**THE PORT AUTHORITY OF NEW YORK AND NEW JERSEY  
TWO MONTGOMERY STREET - 1st FLOOR  
JERSEY CITY, NJ 07302**

**ADDENDUM NO. 1**

TO PROSPECTIVE BIDDERS ON CONTRACT **JFK-944.805** – JOHN F. KENNEDY INTERNATIONAL AIRPORT – REPLACEMENT OF SWITCH HOUSE 1 EMERGENCY GENERATOR

Addendum No. 1  
SK-S002-01

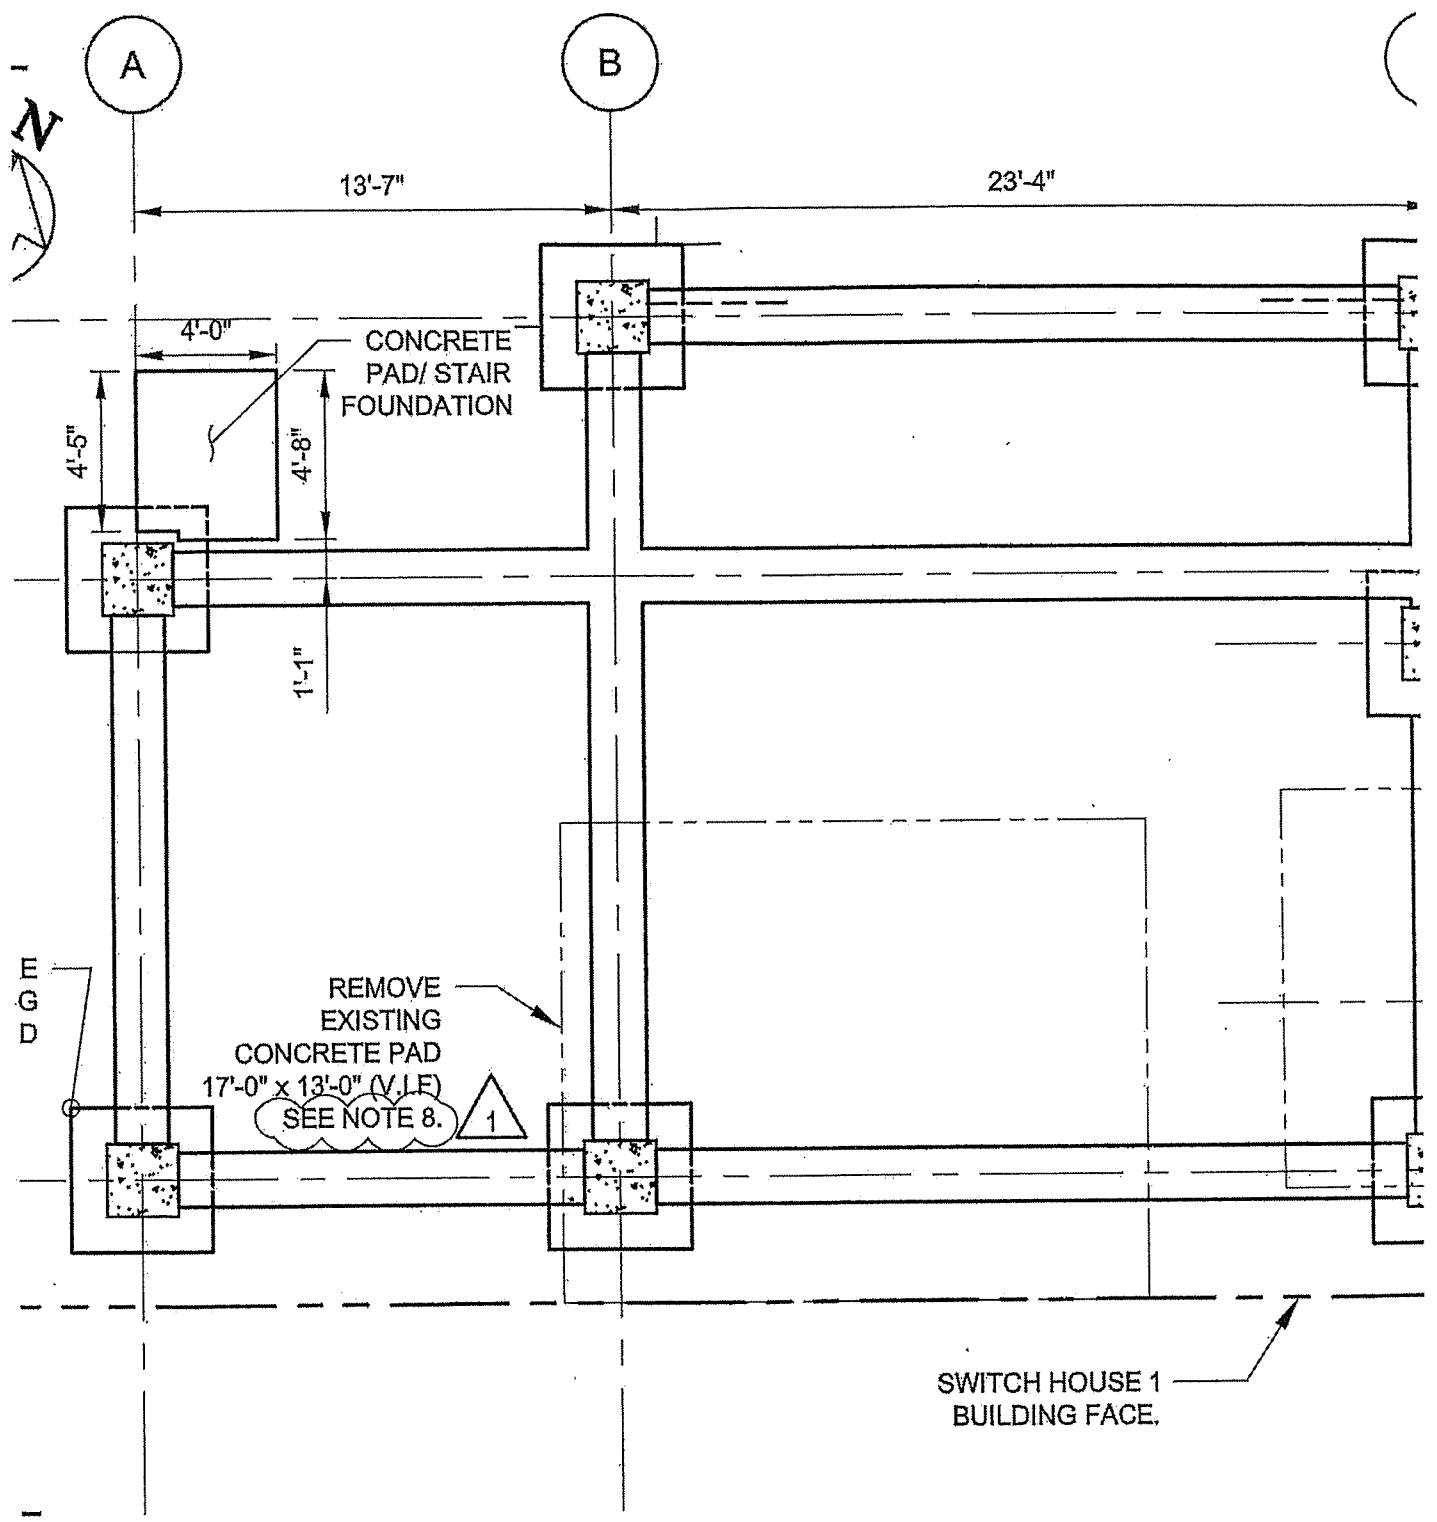
- S002 - Make the following changes:
- A. Immediately following Note 7., insert the following new notes:
    - "8. EXISTING CONCRETE PADS FOR LOAD BANK, TRANSFORMER, AND EMERGENCY GENERATOR ARE 1'-3" THICK WITH A 4'-2" THICK X 2'-0" WIDE PERIMETER HAUNCH.
    - 9. FOR LOCATION FOR THE REMOVAL AND DISPOSAL OF UNDERGROUND STORAGE TANK, SEE CIVIL AND MECHANICAL CONTRACT DRAWINGS. THE EXISTING CONCRETE SLAB BELOW THE TANK IS 22'-0" LENGTH X 9'-6" WIDTH x 0'-8" THICK. THE EXISTING CONCRETE SLAB ON GRADE ABOVE THE TANK IS 28'-0" LENGTH X 14'-0" WIDTH x 0'-8" THICK WITH A 1'-4" THICK x 3'-0" WIDE PERIMETER HAUNCH."
  - B. Revise the drawing as shown in Sketches SK-S002-01 and SK-S002-02 which are attached hereto and made a part hereof.
